Famkam Fashion Ltd.

28th July 2022 & 03rd August 2022

Executive Summary

Observations

Foundation Schedule

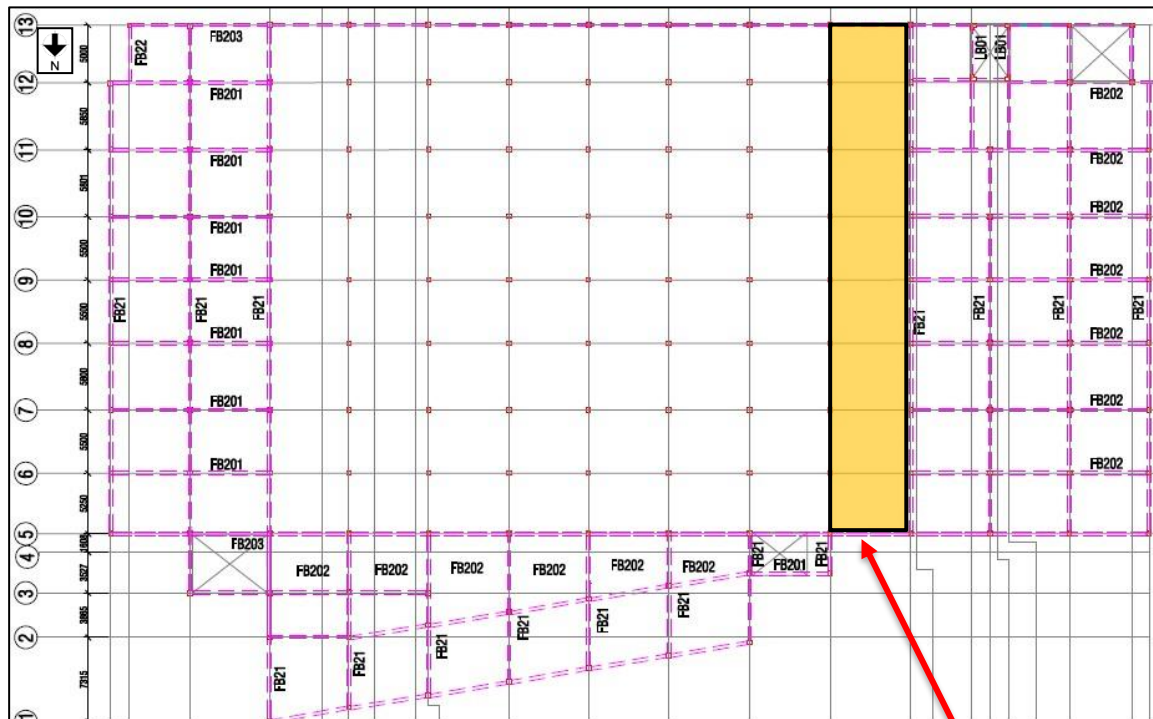
In DEA report, allowable bearing capacity has been considered 2.5 ksf with FoS- 3 at 7 ft. But no reference calculation has been provided.

The cursory calculation indicates that footings are stressed above the normal design limit considering 3 kPa floor live load and average allowable bearing capacity of 1.3 ksf (F.S- 3). The building engineer is required to review design, load, and footing stress and suggest proper recommendations accordingly.

Mezzanine on 2nd floor

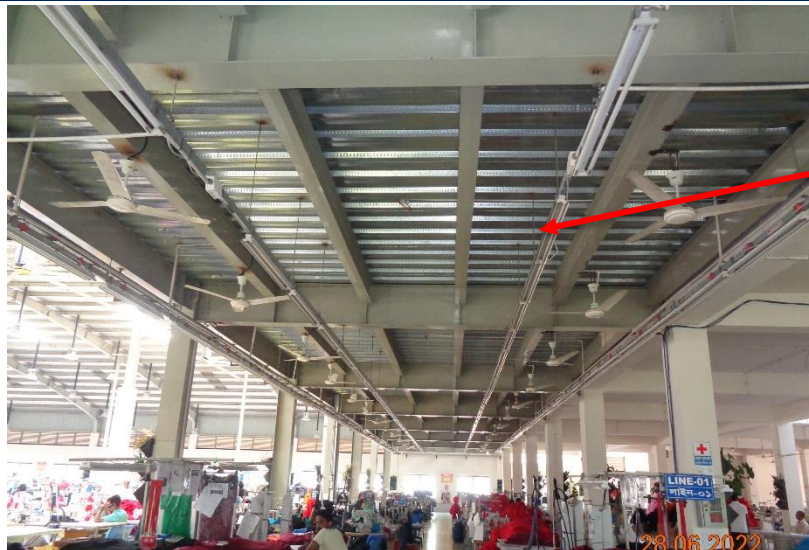
A mezzanine floor was found on 2nd floor. The mezzanine is a steel beam-column frame structure with deck slab. But in the as-built drawing, no information has been provided for the mezzanine.

The Building engineer is required to survey the whole structure and update the as-built drawing as well as design document as per site condition.

Steel roof shed - Lateral load transfer media missing at roof level

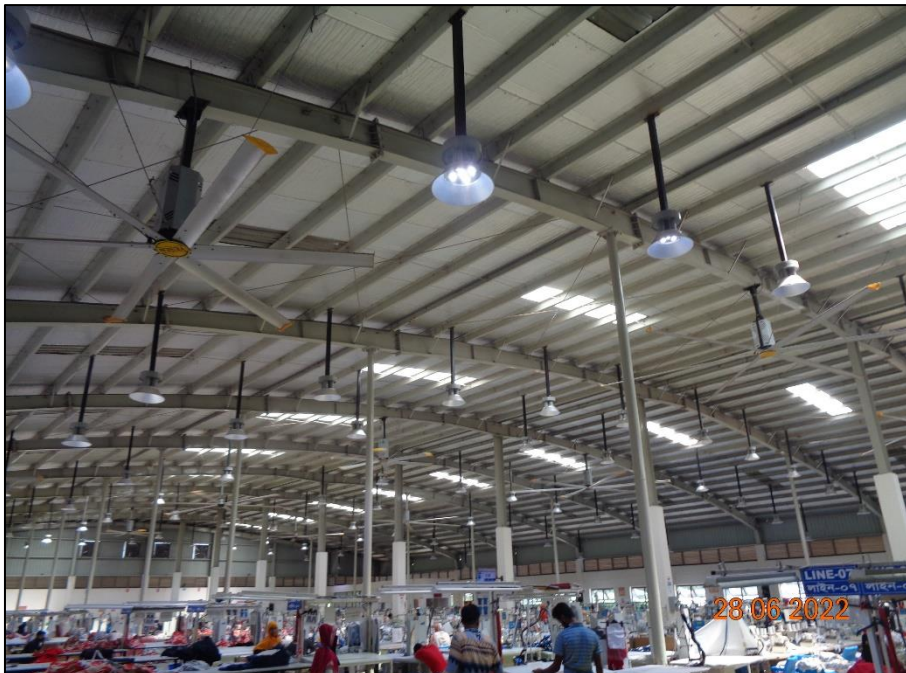
Lateral load transfer media (compression strut) along the ridge and eave is missing. The building engineer to check the lateral load path and review the stability of the structure accordingly.

Plastic water tank at roof

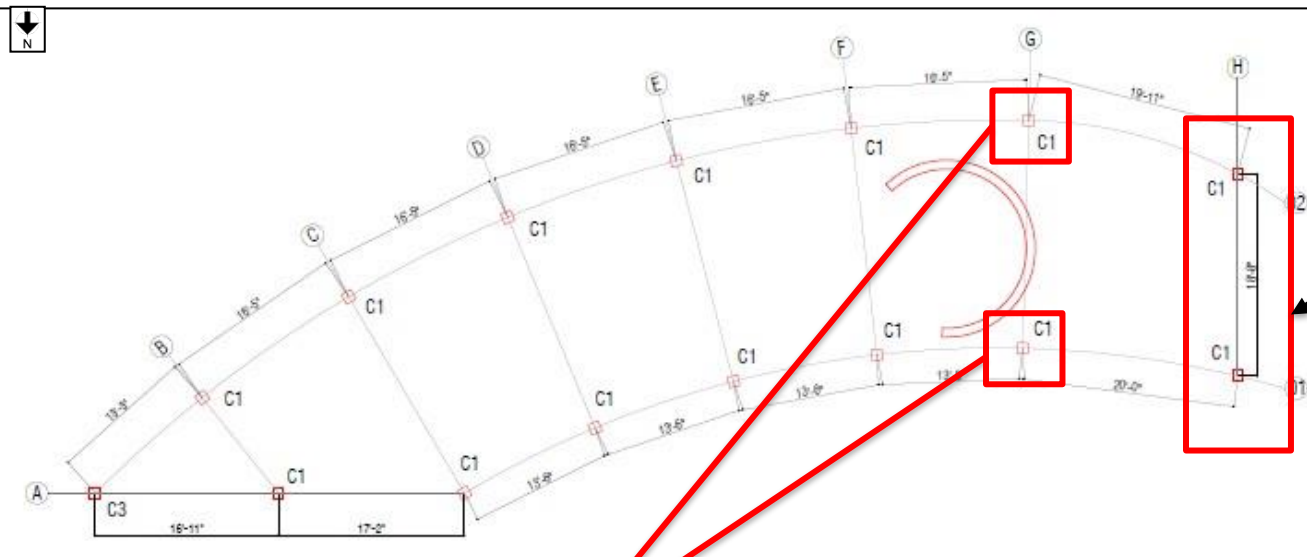
Plastic water tank at roof is not adequately anchored or braced to resist lateral (earthquake) forces.

Adequately anchor and brace all non-structural elements to resist earthquake forces. If the tanks cannot be structurally accommodated, that should be removed.

Column Layout plan

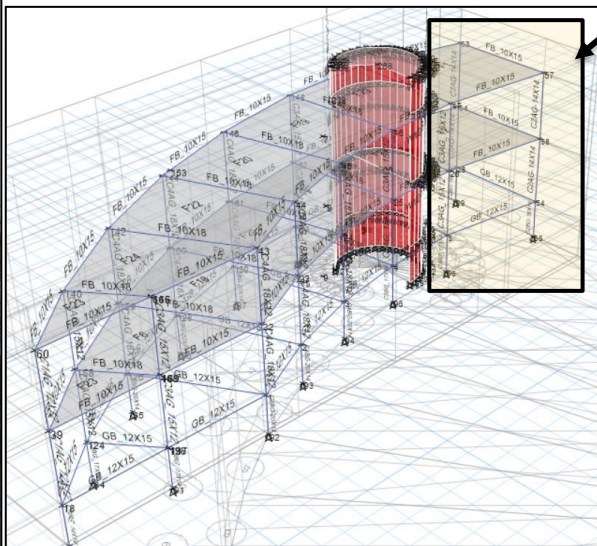
The marked two columns has not been constructed

The marked portion has not been constructed. But the design documents prepared considering the extended part

The building geometry does not match the as-built drawing. Additional column & grid has been shown in the drawing which has not been constructed yet. The building engineer is required to survey the whole structure and update the as-built drawing as well as design document as per site conditions.

Beam Layout

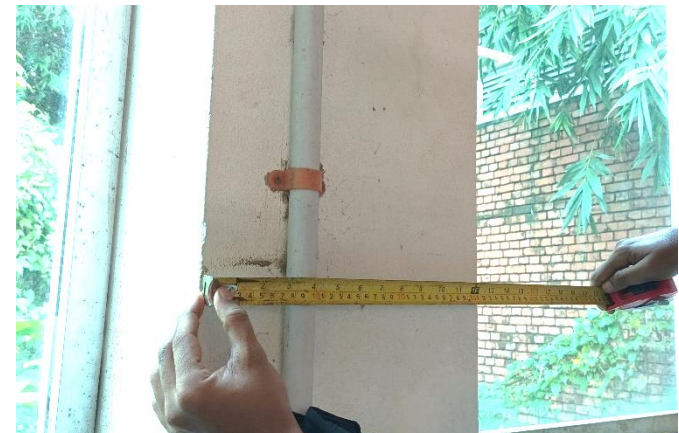
C-02 column
300 mm instead of 375 mm

C-03 column
375 mm instead of 400 mm

The size of C-02 and C-03 columns were found 300 mm & 375 mm instead of 375 mm & 400 mm respectively. The building engineer is required to revise the as-built documentation including the design report and submit it to RSC for review.
